DATE January 5, 2017**PROJECT No.** 1411250045/14000**TO** Andrew Evers
Ministry of Environment and Climate Change**FROM** Alan Hull, Paul Smolkin

**CONSIDERATION OF DAVID WILLIAMS' REVISED BEDROCK GEOLOGY MAP AND
LANDFILL PERFORMANCE AT THE PROPOSED CRRRC SITE**

Attachment: D. Williams Bedrock Geology Map Sheets, revised December 2016

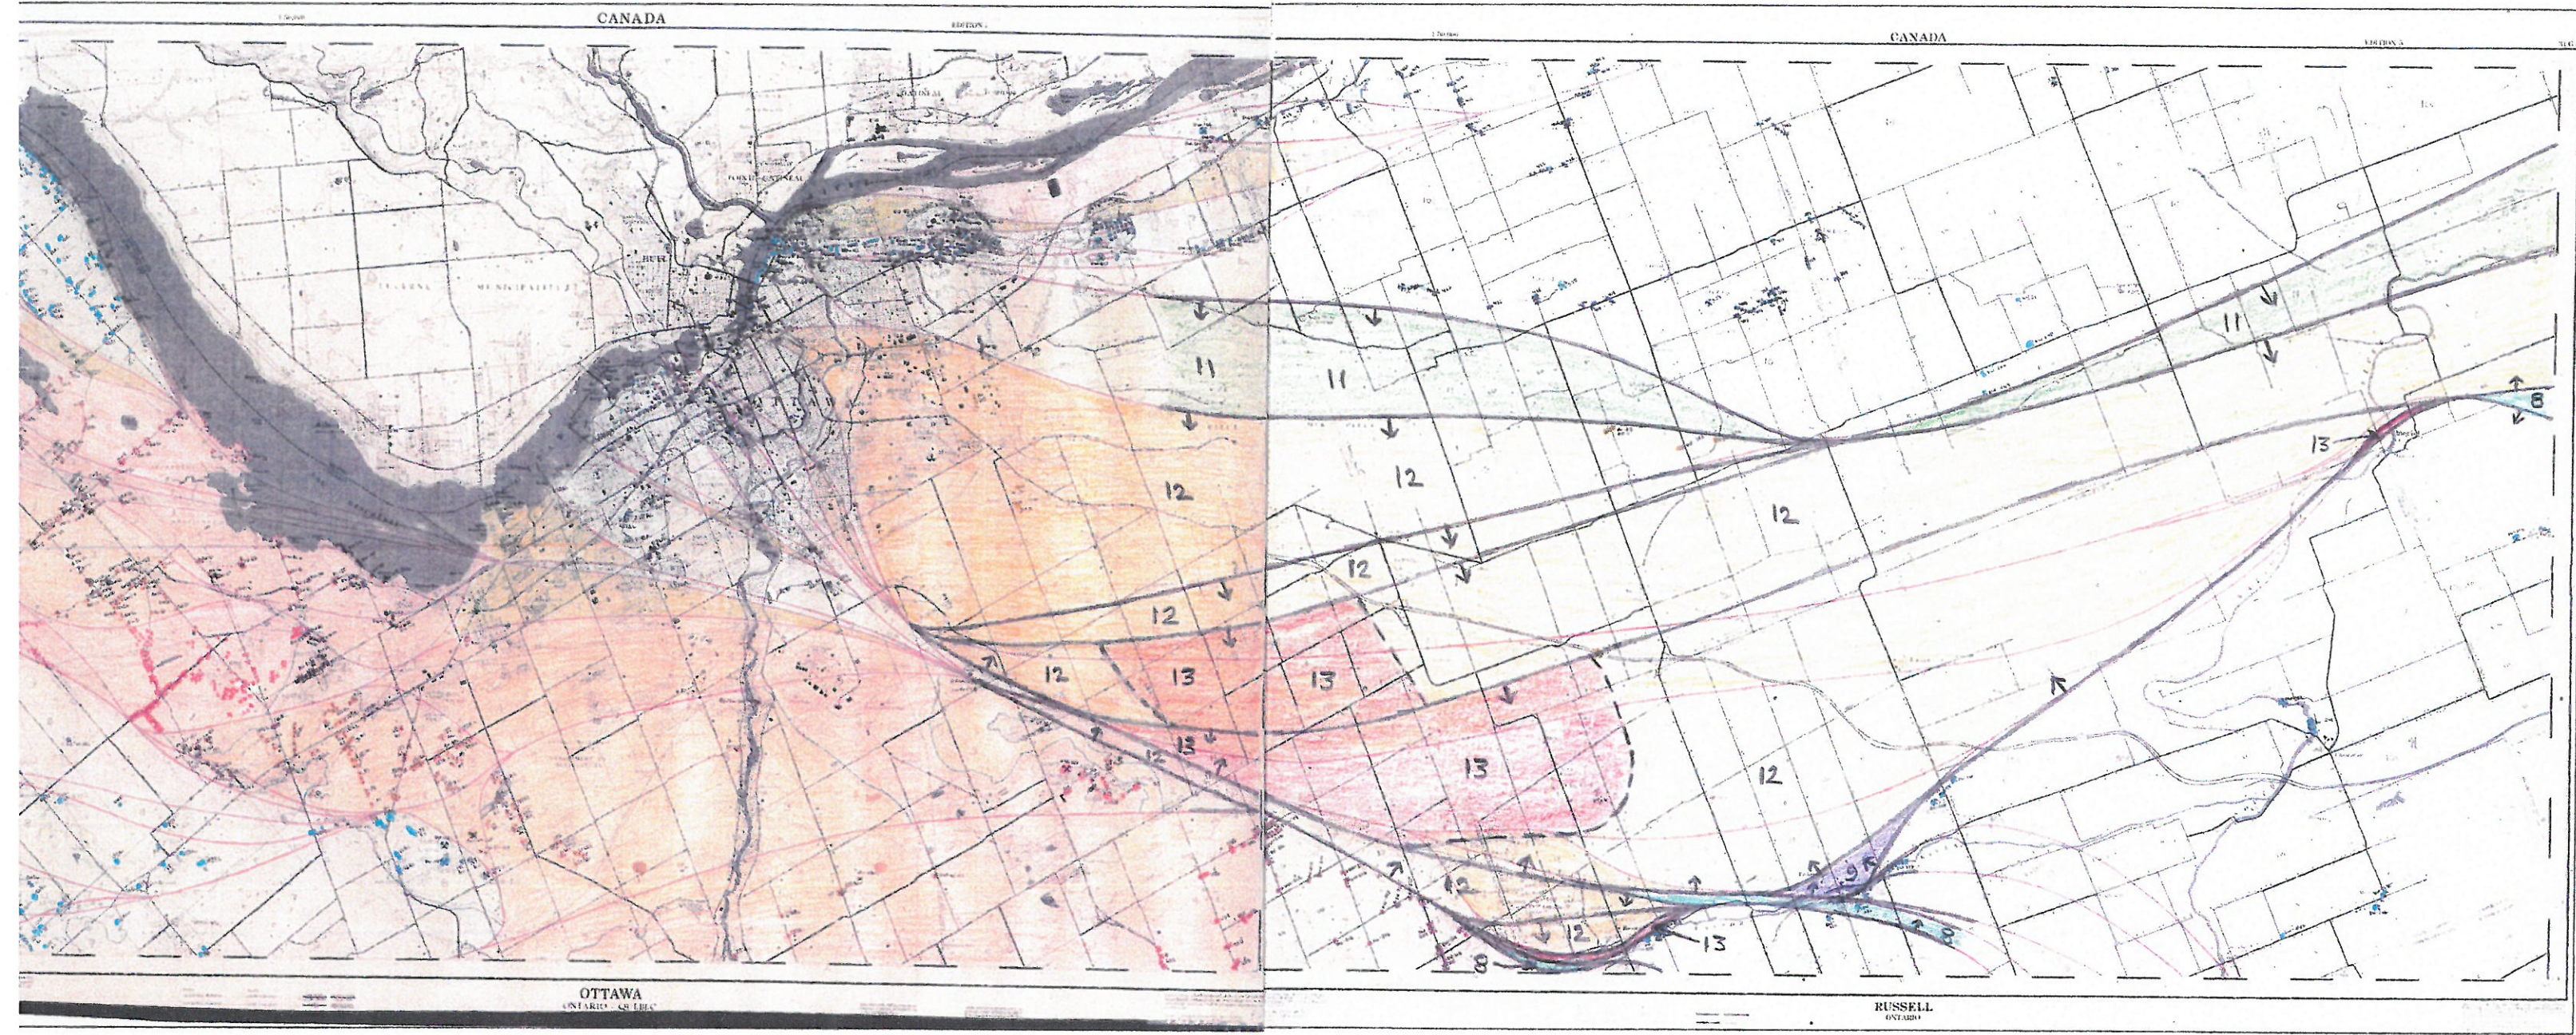
On December 20, 2016 Golder received from Mr. Williams his revised interpretation of the bedrock geology within the area of the Ottawa and Russell map sheets. His revised mapping is attached. As per his June 21, 2016 letter, the inferred fault previously shown as passing through the CRRRC site has been shifted northward approximately 2.2 km. This revised inferred fault was considered in the Golder memorandum of September 12, 2016, which provided further evaluation of potential effects of earthquake shaking on the proposed CRRRC landfill component.

Mr. Williams recently received revised map sheets also present an inferred "new" fault trace trending approximately east-west, with an inferred trace located about 700 m south of the south limit of the proposed CRRRC landfill component. As discussed in Golder's September 12, 2016 memorandum, in our opinion there is no surface or subsurface evidence for the east-west striking faults shown on the previous or recently revised maps prepared by Mr. Williams north of the Gloucester Fault. Nonetheless, Golder has now considered whether the shaking associated with an extreme, low probability earthquake along a fault that Mr. Williams now infers is located 700 m south of the landfill can be expected to produce a significantly different landfill response than an inferred fault 2.2 km north of the landfill footprint, as analysed in our September 12, 2016 memorandum.

- 1) Mr. Williams infers two faults within the bedrock—one about 2.2 km to the north and one about 700 m to the south of the proposed CRRRC landfill component. These faults were not included in his 1991 interpretation, but his underlying geological model remains unchanged. Mr. Williams' interpretations assume that the major geological units within the bedrock formations are unconformably fault-bounded.

- 2) The new inferred faults (and other 1991 inferred faults) are Williams' interpretation that the sedimentary bedrock north of the Gloucester fault is located within a structural basin developed by displacement on a series of south-dipping normal faults, with no displacement greater than about 50 m. Golder considers that none of these faults are related to the present-day tectonic regime, show no evidence for surface rupture in the Holocene (last 11,700 years) and are, therefore, inactive using the fault activity framework of landfill regulations from British Columbia and the United States.

- 3) The new faults inferred by Mr. Williams do not extend under the footprint of the proposed CRRRC site and, therefore, do not pose a potential surface fault rupture hazard to the CRRRC site.

- 4) In his June 21, 2016 letter describing his then revised interpretation, Mr. Williams included the fault 2.2 km to the north of the CRRRC landfill component. Golder's interpretation of the bedrock geology does not support the existence (or Holocene activity) of this fault. Golder nevertheless modeled the potential effects of very strong earthquake ground shaking associated with an **M7+** earthquake generated on this inferred fault 2.2 km from the CRRRC landfill component, as reported in our September 12, 2016 memorandum. The proposed landfill was found to experience very strong shaking and relatively significant displacement during the postulated **M7+** earthquake. However, the predicted displacements of the landfill did not result in dislocation of waste beyond the CRRRC site; and it was concluded that post-earthquake repairs could be readily made to continue safe operation of the CRRRC facility. Golder's conclusions were supported by the observed experience of landfill performance during strong earthquake shaking in the western USA, as reported in our September 12, 2016 memorandum.

- 5) Golder considers that the uncertainties associated with estimating near-field earthquake ground motions measured in past earthquakes indicate that the earthquake strong ground motions within about 5 km of earthquake epicenter or fault rupture are likely very similar. The strength of earthquake shaking and landfill displacement at sites in the near-field (i.e., within about 5 km) are influenced more by the earthquake magnitude and local site conditions than the distance to the earthquake epicenter and/or causative fault (assuming the same earthquake magnitude). That is, the earthquake shaking can reasonably be expected to be similar for an earthquake generated on a fault 2.2 km from the CRRRC landfill component and from an earthquake generated 700 m from the landfill component.

- 6) Golder concludes that in the highly improbable event of a major earthquake along the newly inferred fault 700 m south of the CRRRC landfill, the landfill would experience very similar earthquake shaking and induced landfill displacements as an earthquake generated on the inferred fault located 2.2 km north of the CRRRC landfill. As set out in our September 12, 2016 memorandum, our analysis showed that the proposed CRRRC landfill would be damaged by this shaking, but the waste would remain on the site and the damage to the landfill would be readily remediable.
